# Hadron Energy Inc.'s Responses to NRC Questions from the Review of QAPD Rev 1

February 19, 2026

**Hadron Energy**

# 1. Overall Changes

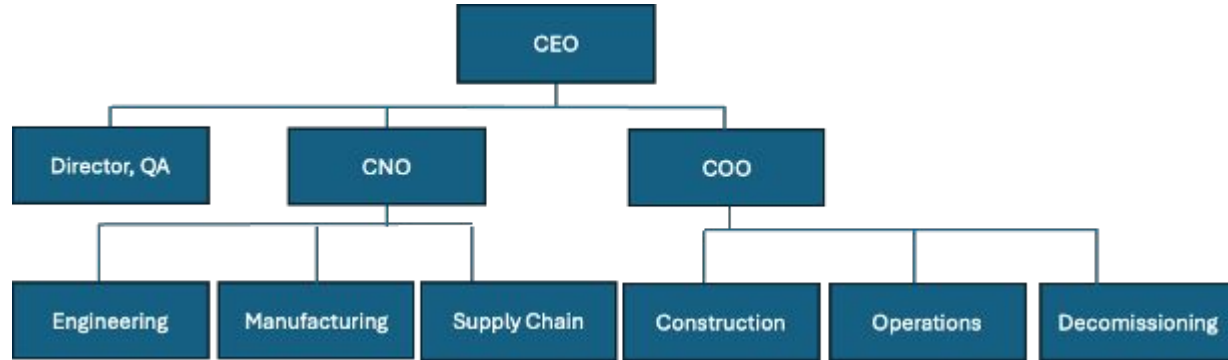
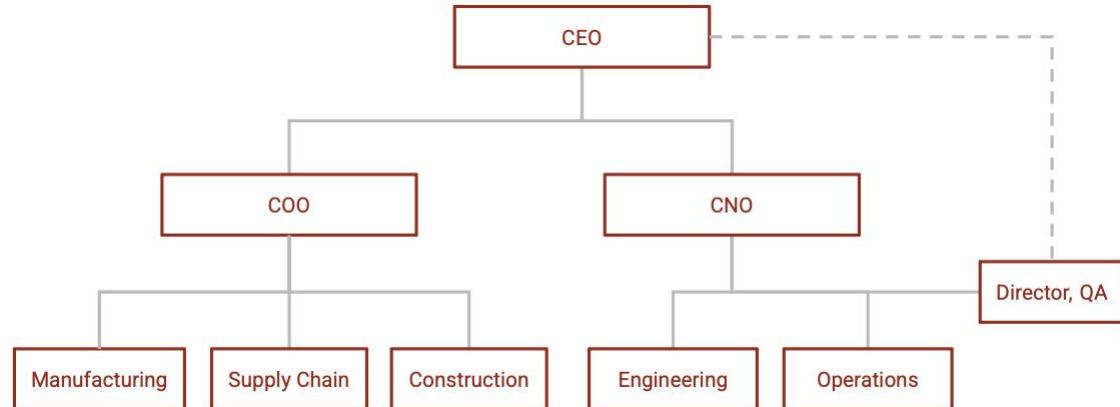
Old:

New:

## 2. Changes to Director, QA Reporting Structure

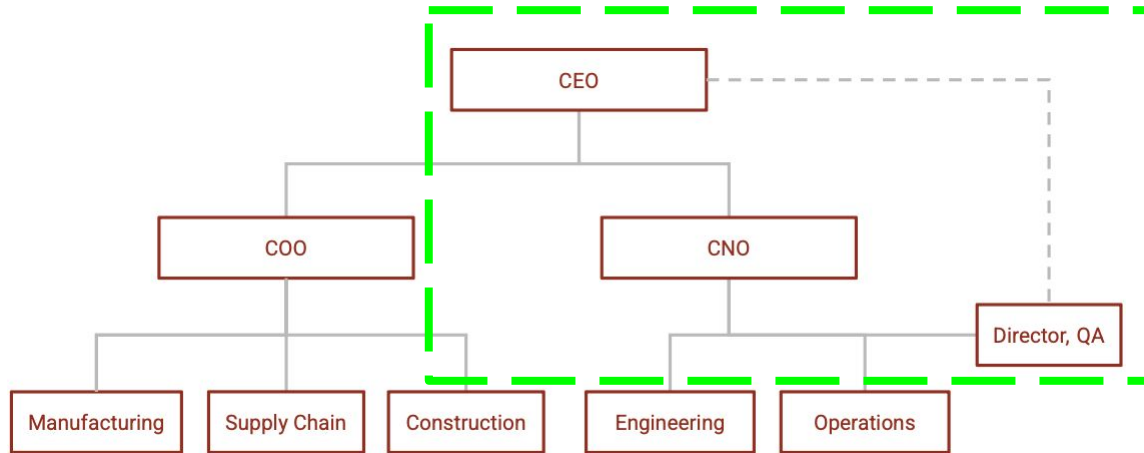
- Director, QA will report to the CNO
- Doing this will enable prompt notification of QA concerns to the CNO and reflects a change in management structure as we enter the public stage of our company

### 3. Reallocation of Responsibilities Under CNO

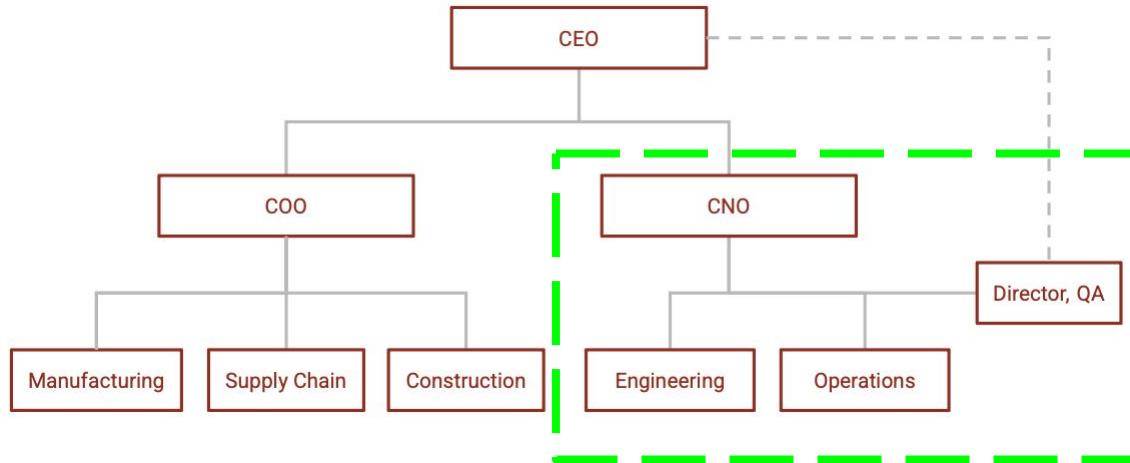
- CNO will now head Engineering and Operations to reflect the human resources and business units dedicated to nuclear-related safety and design concerns.
- In this context, “Operations” refers to the safe operations of the nuclear power plant, not generic business operations.
- CNO will be in close collaboration with COO on nuclear-adjacent matters, such as the QA of Supply Chain, Construction and Manufacturing processes.

## 4. Reallocation of Responsibilities Under COO

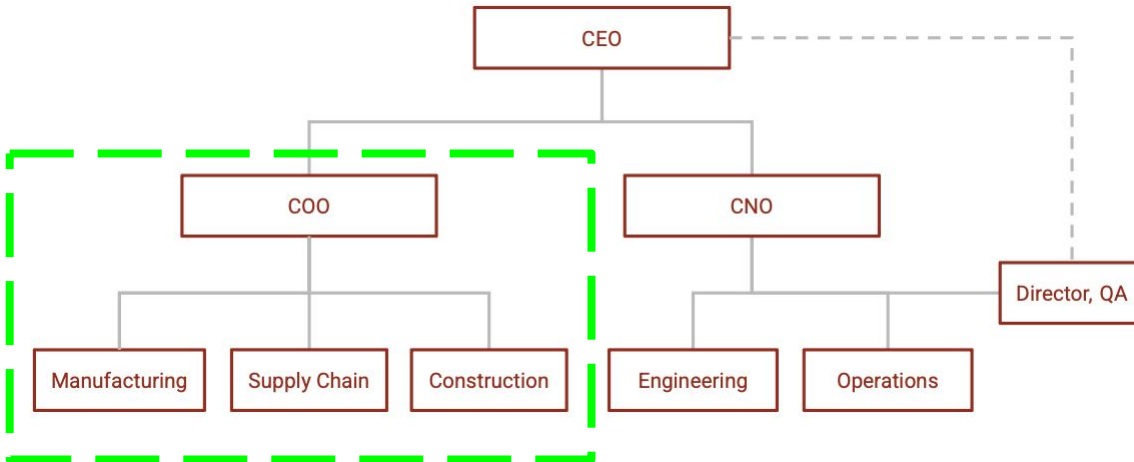
- COO will now lead Manufacturing, Supply Chain and Construction
- Reflects engagement with suppliers, contractors, governments and facilities operators to manufacture and deploy unfueled Hadron MMRs
- COO will be in regular communication with CNO and associated business units to ensure nuclear safety-related needs are met.
